Author's response

Response to the editor and reviewers

Review of: AERA-MIP: Emission pathways, remaining budgets and carbon cycle dynamics compatible with 1.5 °C and 2 °C global warming stabilization

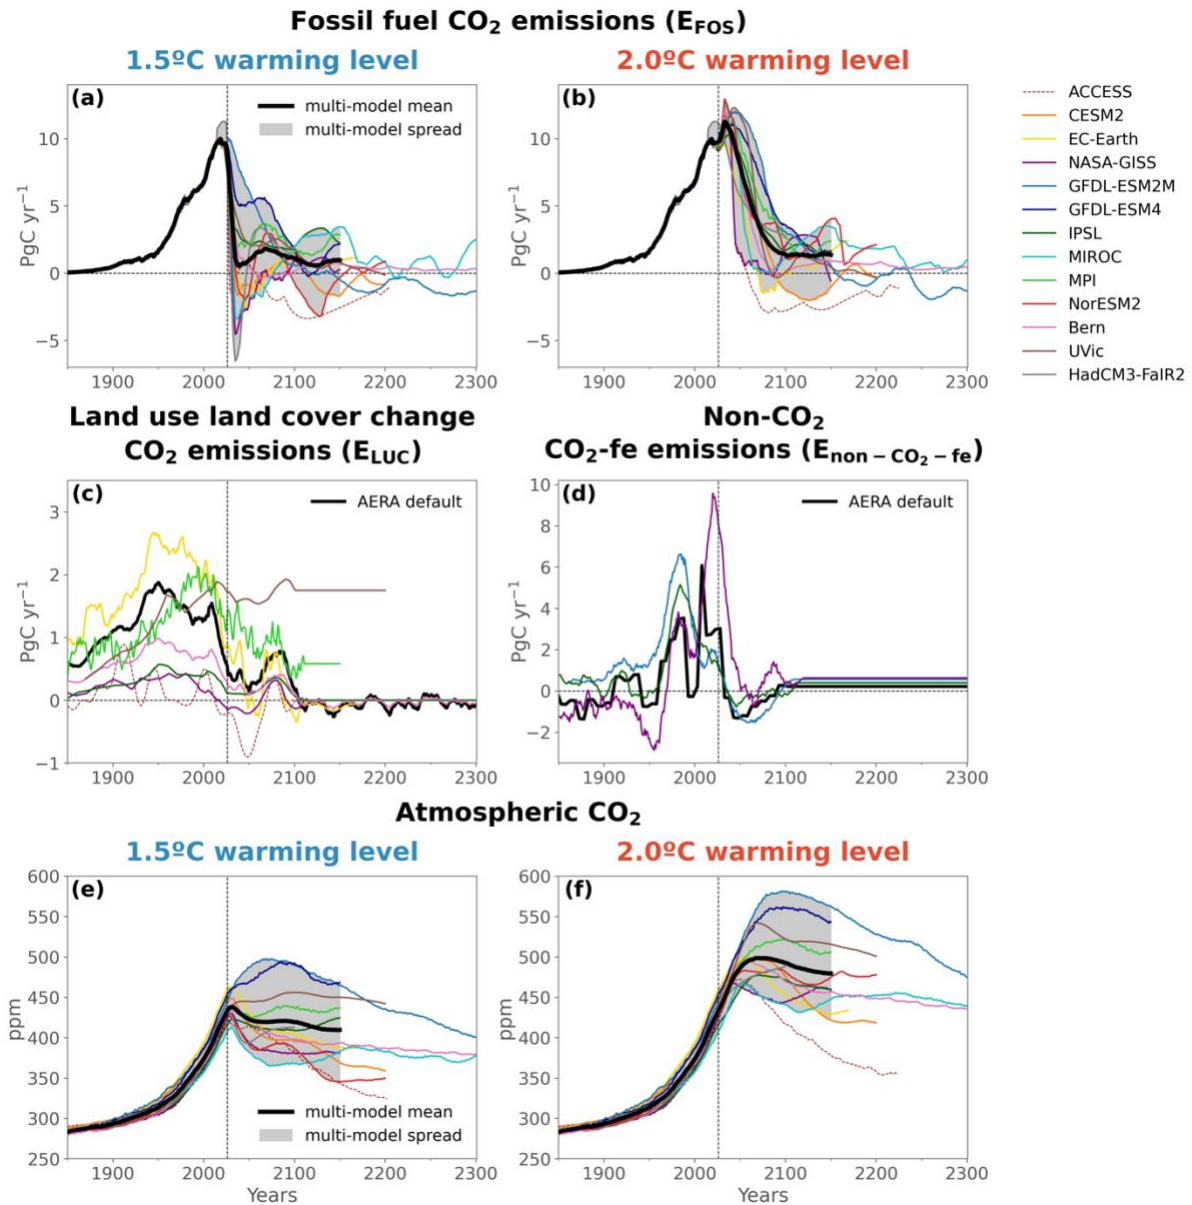
(2) There are three explanations in the paper as to why many of the models project that continued fossil fuel CO₂ emissions could be compatible with temperature stabilization:

The paper shows that all three mechanisms are at work at different times for at least some models. It would be good to collect these explanations together in the discussion to clarify what are the dominant mechanisms on what time-scale and how mechanism may translate to the natural world.

To emphasize the contributions of the fossil-fuel and non-CO₂ radiative forcing agents as well as land use changes, we have included a new figure in the main text that shows the CO₂-fe emissions from all potential sources that are either simulated by the model or prescribed to AERA. The new figure illustrates that CO₂ emissions from land use changes and CO₂-fe emissions from non-CO₂ agents are likely not the primary reasons for the continued positive total CO₂-fe emissions after temperature stabilization.

We have extended section 3.3 (Emissions from fossil fuel, non-CO₂ agents and land use change) as follows:

“The prescribed CO₂-fe emissions from non-CO₂ agents (Figure 3d; colored lines for models that were able to estimate their internal radiative forcing; black line for the others; see Methods) exhibit a rapid decrease after year 2026, reaching maximum negative emissions around year 2054 of -1.4 PgC yr⁻¹ and stabilizing at slightly positive levels of 0.2 PgC yr⁻¹ after 2100 for the default prescribed emissions (black line). CO₂ emissions from land use change (Figure 3c) generally remain slightly positive throughout the 21st century, except in the NASA-GISS, EC-Earth and ACCESS models, where they are temporarily negative. Post-2100, the land-use change CO₂ emissions prescribed to AERA stabilize around zero in all models. Both the non-CO₂ and the land-use change CO₂-fe emissions follow identical trajectories for the 1.5°C and 2.0°C global warming level simulations, as they follow the SSP126 scenario for both warming levels.

It is important to mention that the simulated model-specific CO₂ emissions from land use change and CO₂-fe emissions from non-CO₂ agents are not available as output from all models. Nevertheless, negative CO₂-fe emissions from non-CO₂ radiative forcing agents are only possible if the radiative forcing from these agents is decreasing (see equation above). However, the radiative forcing agents follow the SSP126 or RCP26 scenario and after 2100 they are set to constant values for all models suggesting that substantial negative non-CO₂ radiative forcing is unlikely post-2100. In addition, land-use is also set to be constant after 2100. Considering that CO₂ emissions from both land use change and non-CO₂ agents are likely to be zero or slightly above zero after temperature stabilization, it is reasonable to conclude that the positive CO₂-fe and fossil fuel CO₂ emissions after stabilizing warming are more likely a consequence of the overall negative ZEC rather than net negative forcing from non-CO₂ forcing or from land use change.”

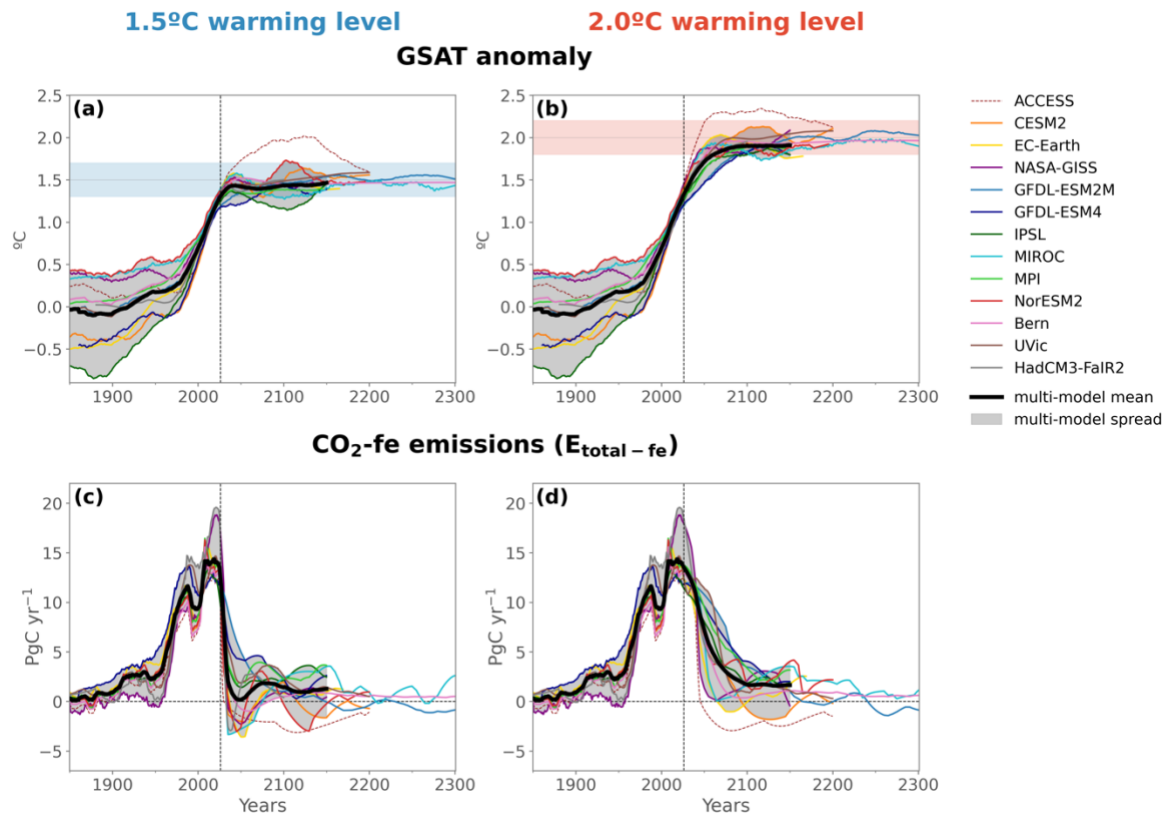
Lines 216-217. Is the +/- 10% correspond to the light red and blue shading in fig. 1? Or is it the +/- 0.2C referred to on line 217? Either way, please note that in the figure caption.

As a result of the revisions, figure 2 of the main text has also been slightly modified. It now shows the temperature and CO₂-fe emissions response.

We cannot find the +/-10% statement the reviewer is referring to. In addition, we assume that the reviewer refers to Fig. 2 and not Fig. 1, as blue and red shading is only shown in Fig. 2. We have added to the caption of Figure 2: "The horizontal shading in (a) and (b) indicates the uncertainty with which anthropogenic warming can be determined ($\pm 0.2^{\circ}\text{C}$)"

Figure R1: Simulated CO₂ emissions from fossil fuel and land use change for the 1.5°C and 2.0°C warming levels.

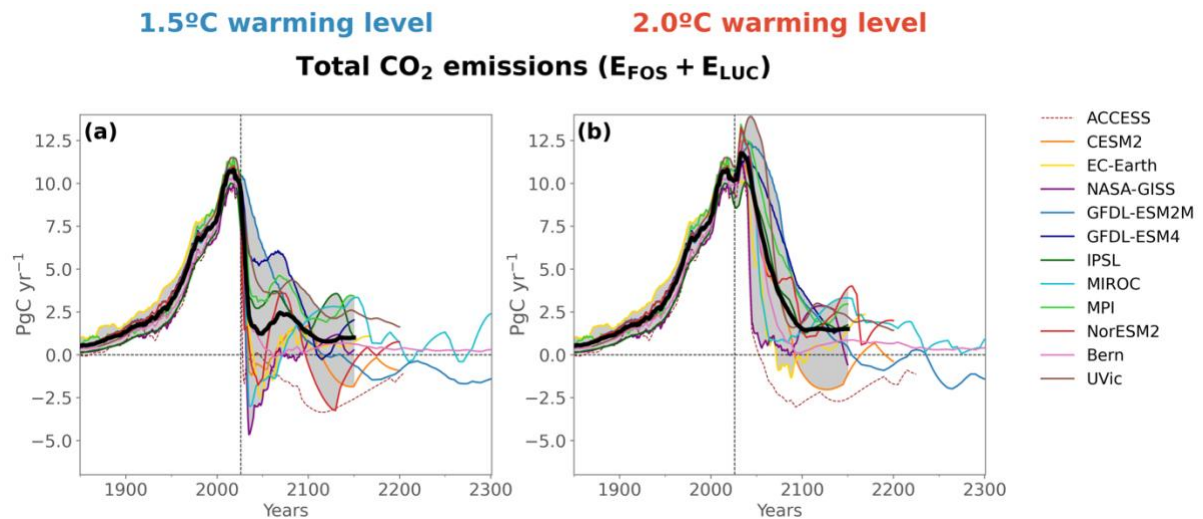
(3) Related to comment 2, I suggest adding a section on anthropogenic carbon emissions similar to section 3.3. That is, I think it is also important to highlight what the sum of fossil fuel and land use change emissions to distinguish between true continued net CO₂ emissions and fossil fuel emissions being compensated by net-negative land use change emissions.

The combined CO₂ emissions from fossil fuels and land use change are only marginally different from fossil fuel alone, as land use change CO₂ emissions after 2026, especially during the stabilization phase, are minimal. Please see Figure R1 for the combined CO₂ emission from fossil fuel and land use change. As we have already included a new Figure 3 with land use change CO₂ emissions in the main text, along with a paragraph describing land-use change emissions (refer to the reply to the previous comment), we do not include Figure R1 in the manuscript.

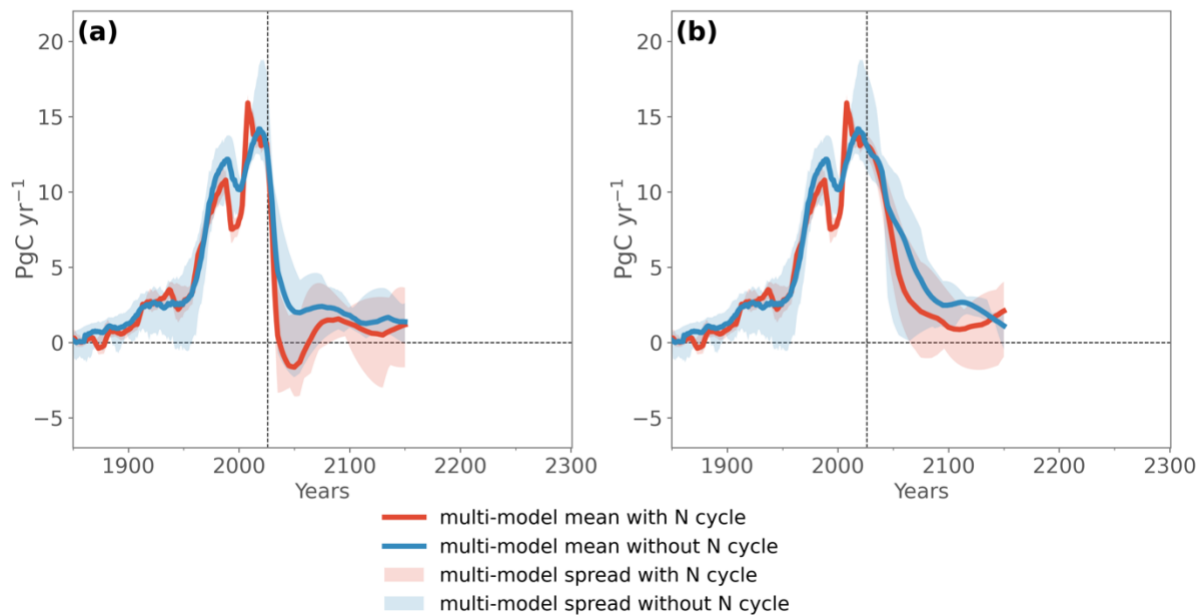
(4) When examining the model's carbon cycle responses you should examine whether models with a terrestrial nitrogen cycle have a different response.

We have now added a paragraph to the discussion section and also included a new Figure in the Appendix.

“Using CMIP6 models, Arora et al. (2020) demonstrated that those models with a terrestrial nitrogen cycle typically show lower carbon uptake than those without, because of widespread nitrogen limitation of the vegetative carbon sink. This finding has been corroborated by the ZECMIP analysis (MacDougall et al. (2020)). A lower terrestrial carbon sink in models with a terrestrial nitrogen cycle implies stronger reductions in CO₂-fe emissions in those models. This is indeed simulated in both the 1.5°C and 2.0°C global warming level scenarios (see Figure B8). For example, under the 1.5°C global warming scenario, the multi-model mean CO₂-fe emissions in 2050 for the six models including a terrestrial nitrogen cycle are -1.6 PgC yr⁻¹, compared to 2.0 PgC yr⁻¹ without it. Averaged between 2100-2150, the CO₂-fe emissions are 0.8 PgC yr⁻¹ for models with a terrestrial nitrogen cycle and 1.5 PgC yr⁻¹ without. The minimum CO₂-fe emissions in the 1.5°C scenario between 2026 and 2150 are -1.6 PgC yr⁻¹ in the models with a nitrogen cycle, and 1.3 PgC yr⁻¹ in the models without. The analysis indicates that part of the spread in CO₂-fe emissions pathways can potentially be attributed to whether models include a terrestrial nitrogen cycle. However, the model spread in CO₂-fe emissions also emerges due to other model differences, such as in ocean carbon uptake (e.g., Terhaar et al. 2022) or climate sensitivity (Cox et al. 2018).”

Figure A3: Simulated multi-model mean CO₂-fe emissions for the 1.5°C and 2.0°C warming levels with and without including the ACCESS model.

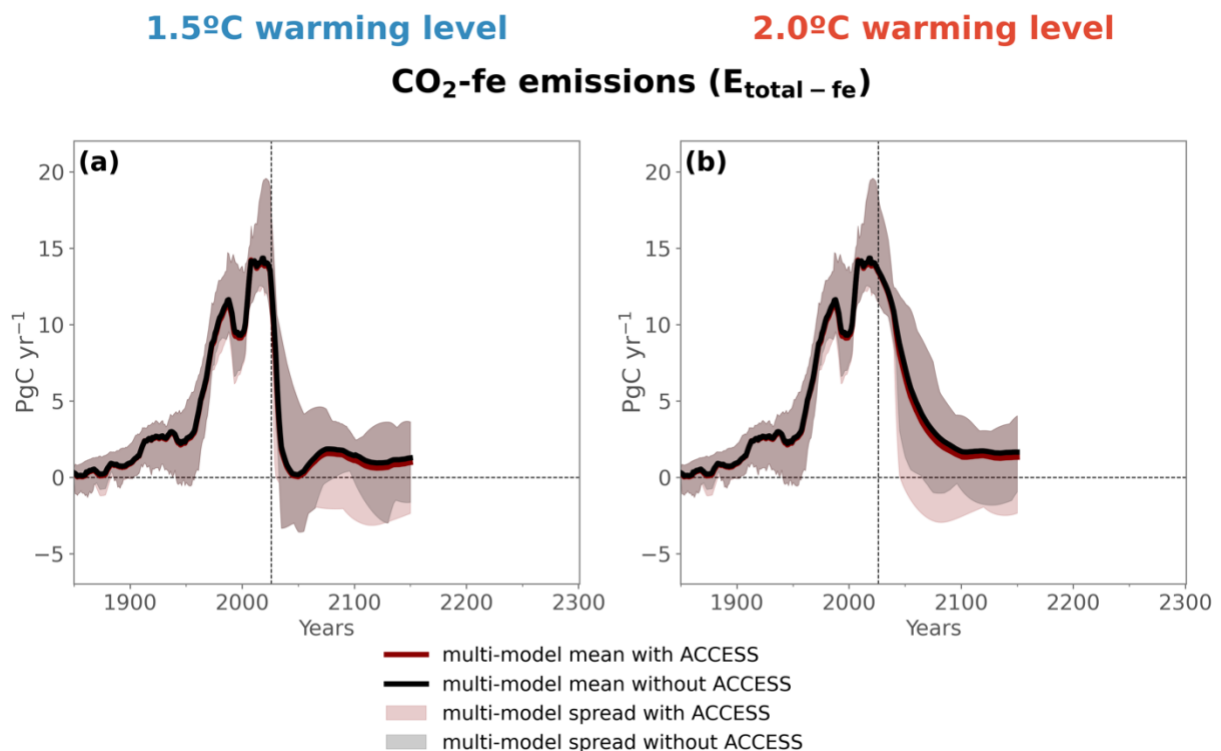
My second major concern is about how this manuscript treats ACCESS as an outlier. The overall hypothesis of the manuscript seems to be that it is possible to apply the AERA in a set of full-complexity ESMs, but then the one model that does not work as intended is not fully included in the analysis. The implications of this would seem to be pretty important, as it implies that certain types of physical uncertainties might lead to a failure of climate policies that are structured like the AERA approach. The explanation on lines 132-136 makes sense, but what is the evidence for it? How confident are we that this mismatch in non-CO2 forcing is not pointing to a real uncertainty that we need to consider in remaining emissions budgets? So I would advocate keeping ACCESS within the ensemble statistics unless a stronger case is made that the non-CO2 forcing estimate difference represents an unphysical model artifact.

We note that the ACCESS model also converges to both prescribed temperature levels, but substantially later than all other models. Therefore, we do not fully agree that, according to ACCESS, this would indicate a failure of climate policies. In AERA, an existing mismatch between actual non-CO₂ emissions and those supplied to the algorithm is not corrected for. As a policy instrument, scientists would revise initially biased non-CO₂ emissions estimates over time, allowing temperatures to converge faster.

We have, however, now included the ACCESS model in a new figure in the Appendix (Figure A3), which depicts the multi-model mean CO₂-fe emissions pathways with and without ACCESS. For example in the 1.5°C scenario, the multi-model mean CO₂-fe emissions in year 2050 are 0.03 PgC yr⁻¹ with ACCESS and 0.16 PgC yr⁻¹ without ACCESS. Between 2100 and 2150, the average CO₂-fe emissions are 0.79 PgC yr⁻¹ with ACCESS and 1.66 PgC yr⁻¹ without ACCESS. Thus, the multi-model mean emissions pathways are nearly identical. We have added the following to the text: “ACCESS-ESM1-5 also converges to both prescribed temperature levels, but substantially later than all other models.” and “However, the inclusion of the ACCESS model in the ensemble modifies our results only slightly”.

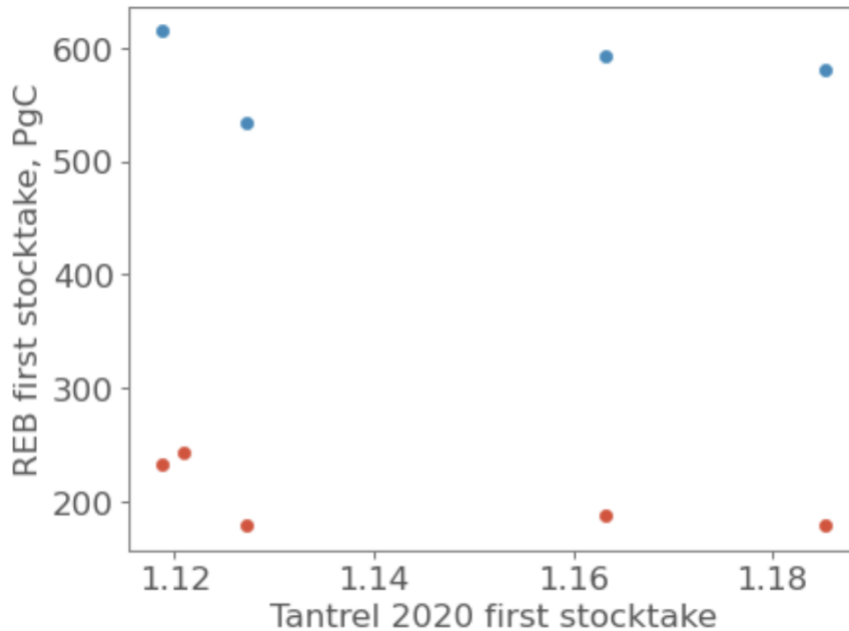
I am also a bit confused about the implications of removing the historical warming differences between the models by lining them up so that they all pass through 1.22 degrees at year 2020. How was this handled for the models with multiple ensemble members -- were the ensemble members each lined up at their own year 2020 temperature, and thus they have different absolute temperature setpoints? If so, is there any correlation between the REBs and the absolute temperature at 2020 across the ensemble members? Or was the ensemble-mean global temperature used for the year 2020 value so that all members have the same absolute

temperature setpoint? Given that there is real uncertainty in the current level of global warming due to internal variability (e.g. as pointed out on line 218), what are the implications of this choice on the uncertainty in REBs? Some further discussion of this would be helpful.

Yes, each ensemble member was aligned to its own anthropogenic temperature in 2020, resulting in slightly different absolute temperatures for that year. However, the maximum difference between ensemble members in 2020 is very small. For instance, in the 5-member GFDL ensemble simulation, this difference is only 0.067°C. We have added to the text: “*Each initial condition ensemble member has its own anthropogenic temperature in year 2020, resulting in very small differences in absolute temperatures for that year (maximum differences across GFDL ESM2M ensemble members of 0.067°C).*”

Thus, while the REB depends on the absolute temperature in 2020, it also depends on the absolute temperature of the current stocktake, which means we do not find a clear linear relationship between the two across the GFDL ensemble members (see Figure R2).
